State of New Mexico
Energy, Minerals and Natural ResourcesForm C-403
Revised August 1, 2011

WELL API NO. 30-015-33149
5. Indicate Type of Lease STATE FEE X
6. State Oil & Gas Lease No.
7. Lease Name or Unit Agreement Name MEAD
8. Well Number 005
9. OGRID Number 372165
10. Pool name or Wildcat CARLSBAD; MORROW, S. (PRO GAS)

SUNDRY NOTICES AND REPORTS ON WELLS (DO NOT USE THIS FORM FOR PROPOSALS TO DRILL OR TO DEEPEN OR PLUG BACK TO A DIFFERENT RESERVOIR. USE "APPLICATION FOR PERMIT" (FORM C-101) FOR SUCH PROPOSALS.)	
1. Type of Well: Oil Well Gas Well X Other	
2. Name of Operator PERMIAN RESOURCES OPERATING, LLC	
3. Address of Operator 300 N. MARIENFELD ST., SUITE 1000, MIDLAND, TEXAS 79701	
4. Well Location Unit Letter P : 660 feet from the SOUTH line and 1060 feet from the EAST line Section 05 Township 22S Range 27E NMPM EDDY County	
11. Elevation (Show whether DR, RKB, RT, GR, etc.) 3,119' – GR

Permian Resources Op.

PROPOSED

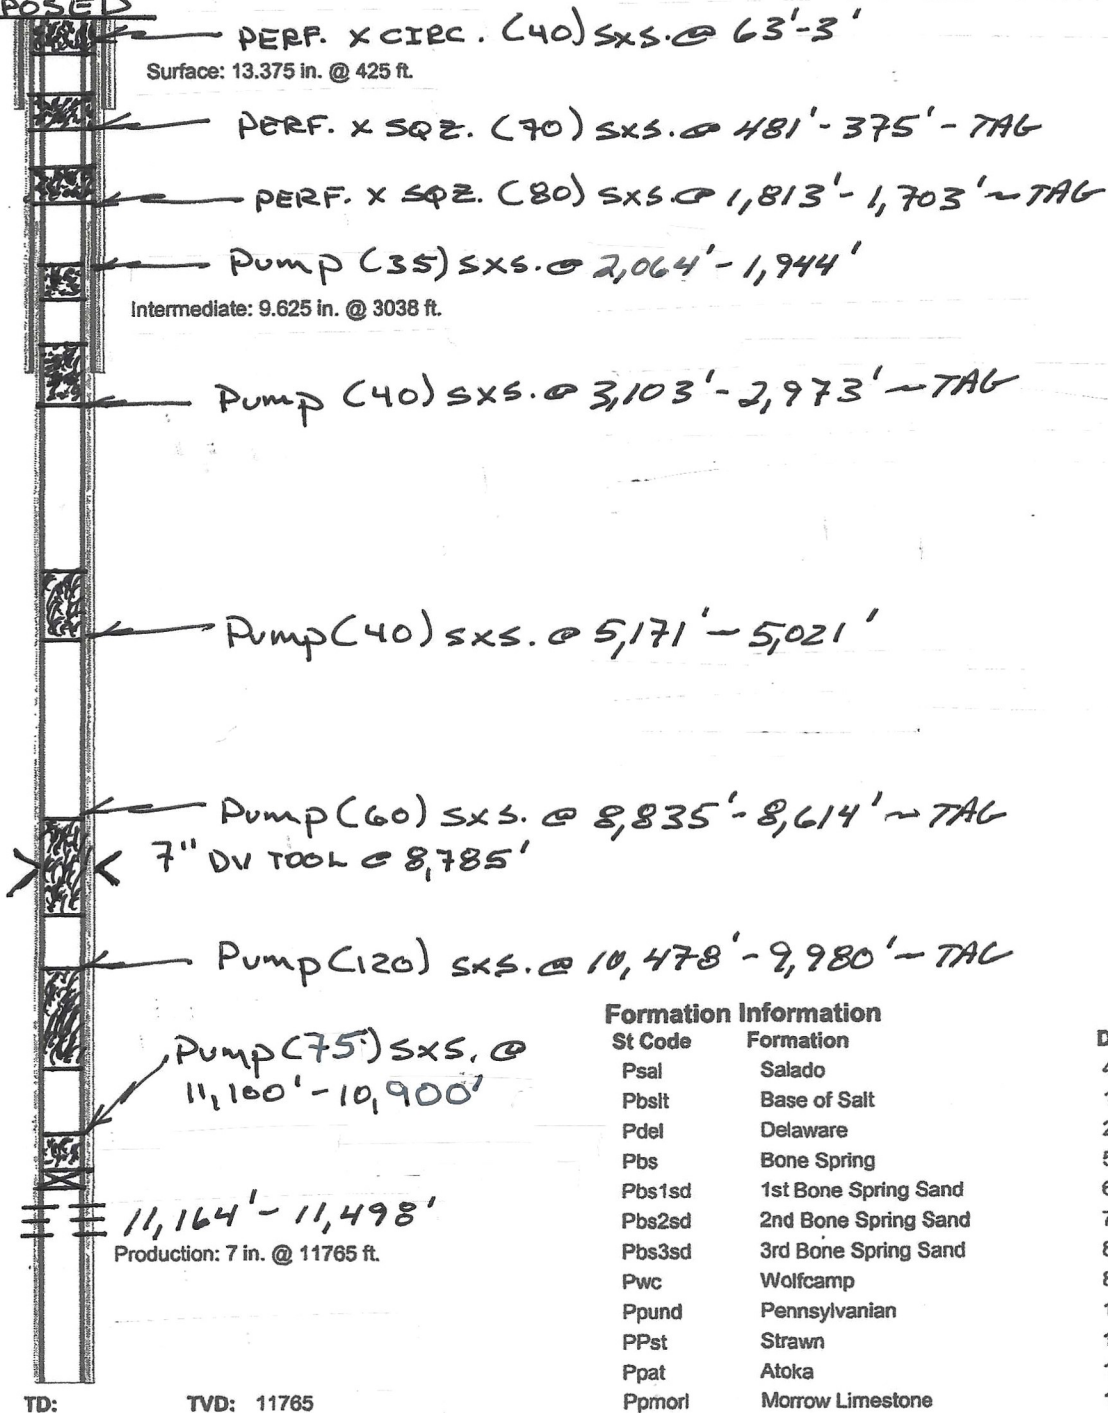
See CBL to add perforations -

Plugging Plan

- 1 Set CIBP @ 11110' – Test casing 500psi/30min – Bubble Test – Run CBL to surface
- 2 PUMP (45) sx. CLASS "H" CMT.@ 11,100'-10,900' (T/MRRW.); WOC 6hrs X TAG TOC 10900' or higher
- 3 CIRC. WELL W/ M.L.F.;
- 4 PUMP (90) sx. CLASS "H" CMT.@ 10,478'-9,980' (T/ATOKA, T/STWN., T/PENN); WOC 6hrs X TAG TOC 9980' or higher
- 5 PUMP (38) sx. CLASS " H " CMT. @8,835'-8,614' (7" DV TOOL, T/WLCP.); WOC 6 hrs. X TAG TOC 8614' or higher
- 6 Spot 20 sx cmt 5700' – Spacer
- 7 PUMP (40) SXS. CLASS "C" CMT. @5,171'-5,021' (T/BNSG.).
- 8 PUMP (40) sx. CLASS "C" CMT. @3,103'-2,973' (9-5/8" CSG.SHOE); WOC X TAG TOC
- 9 PUMP (35) SXS. CLASS "C" CMT. @2,064'-1,944' (T/DLWR.).
- 10 PERF. X ATTEMPT TO SQZ. (80) sx. CLASS "C" CMT.@ 1,813'-1,703' (B/SALT); WOC 6hrs X TAG TOC 1703' or higher
- 11 PERF. X ATTEMPT TO SQZ CMT. @ 481'-Surface (T/SALT, 13-3/8" CSG.SHOE);

DIG OUT X CUT OFF WELLHEAD 3' B.G.L.; VERIFY CMT. TO SURF. ON ALL ANNULI; WELD ON STEEL PLATE TO CSGS. X INSTALL DRY HOLE MARKER
